From: Andy Rollinson
Sent: 12 July 2019 12:31
To: Maria Calderon
Cc: Office; Hilary Saunders
Subject: FW: Emailing: greenhouse detail Thirley Cotes Farm.

Greenhouse / Flat Roof Detail
Walnut Cottage
Thirley Cotes Farm
scale 1 / 20 at A3
8/7/19.

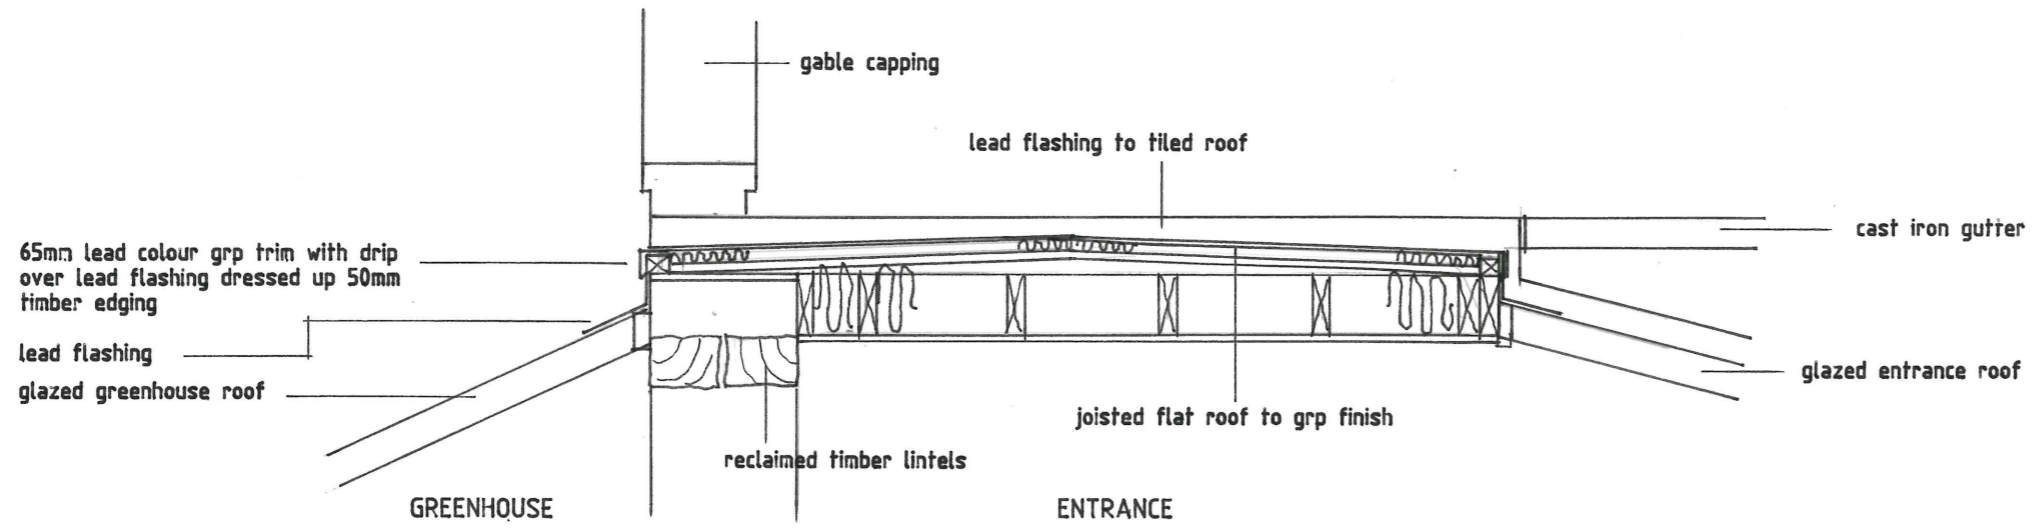
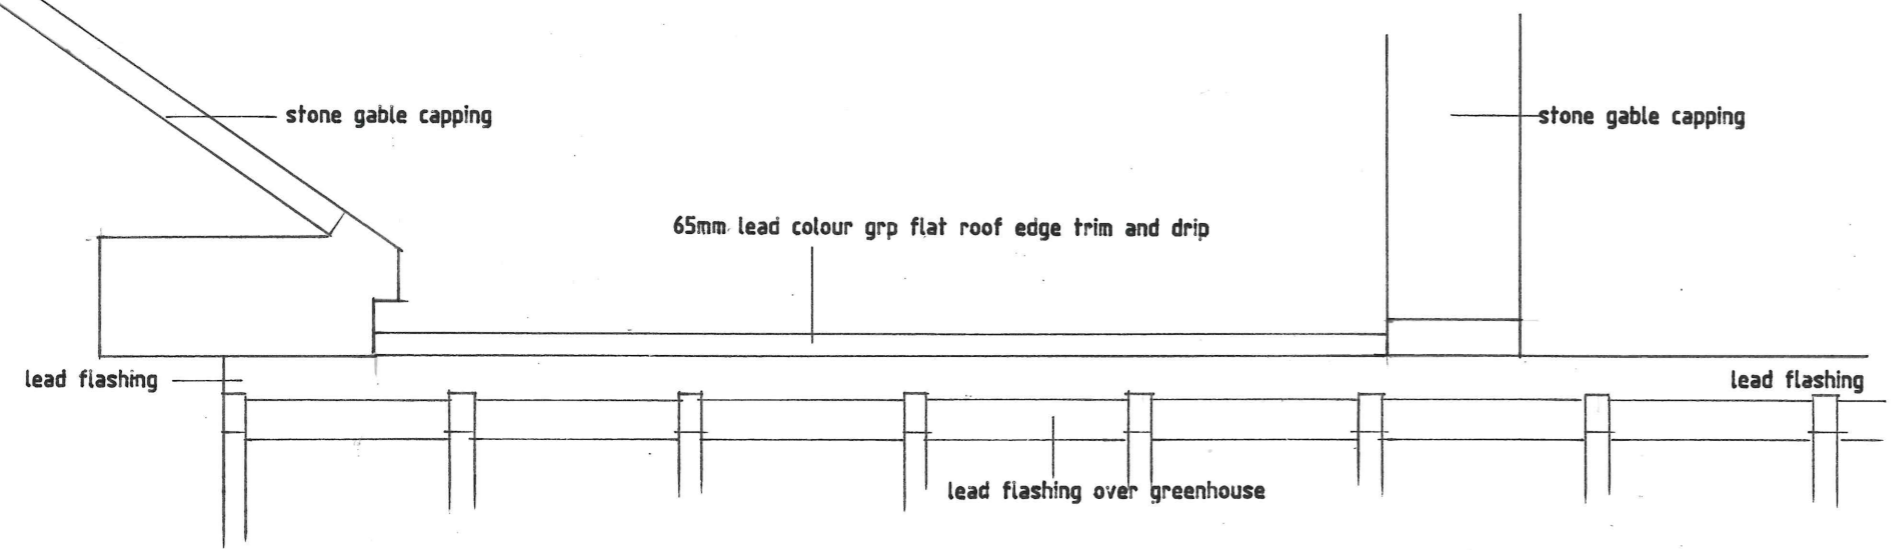
I attach detail of flat roof / greenhouse as requested by Maria.

The detail is very simple and comes down to a lead coloured grp flat roof trim over the lead flashing which will give a break between the two buildings rather than linking the stone

capping's as before which in my view is a much better detail but it does positively link the two buildings.
